Serial No. 10/622,858

# **Amendments to the Drawings:**

#### Remarks/Arguments:

Annotated Sheet 10/10 Serial No. 10/622,858

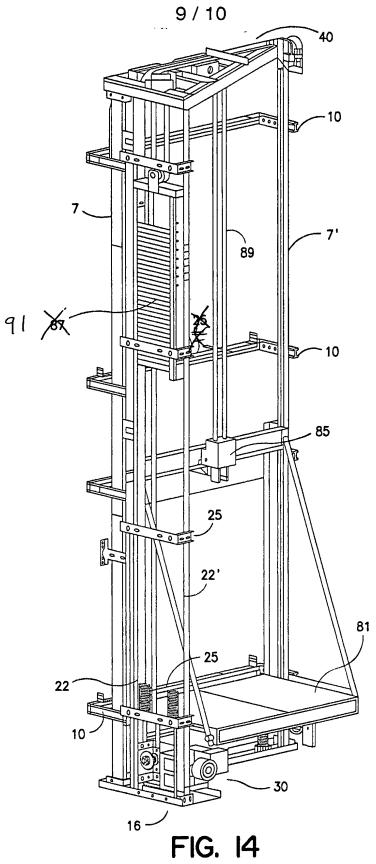
By the present amendment, and as described in more detail in the Remarks Section of this Amendment, Figs. 8, 14 and 15 (or sheets 4/10, 9/10 and 10/10) are amended to correct element numbering of certain features of the invention. Attached as an Appendix to this paper is a complete set of Replacement Sheets (1/10 - 10/10) showing these changes as well as replacing drawing sheets originally filed with hand-numbered elements.

The Examiner objected to the drawings as failing to comply with 37 CFR 1.84(p)(4) because reference characters "22" and "51" have both been used to designate the counterweight guide rail in Fig. 8. In the present amendment, Fig. 8 has been amended to properly correct element numbering with respect to reference characters 22 and 51. Additionally, the Examiner has noted that reference character "87" has been used to designate both lower bolsters and counter weight assembly. Accordingly, in the present amendment, Applicant has amended Figs. 14 and 15 to show the counterweight assembly with reference character "91". Finally, Fig. 15 that was originally filed has been amended to include element numbering. Also, a complete set of drawings is included with the present Amendment to replace originally filed drawing sheets 1-10 with replacement drawing sheets 1-10 that eliminate the hand-written element numbering.
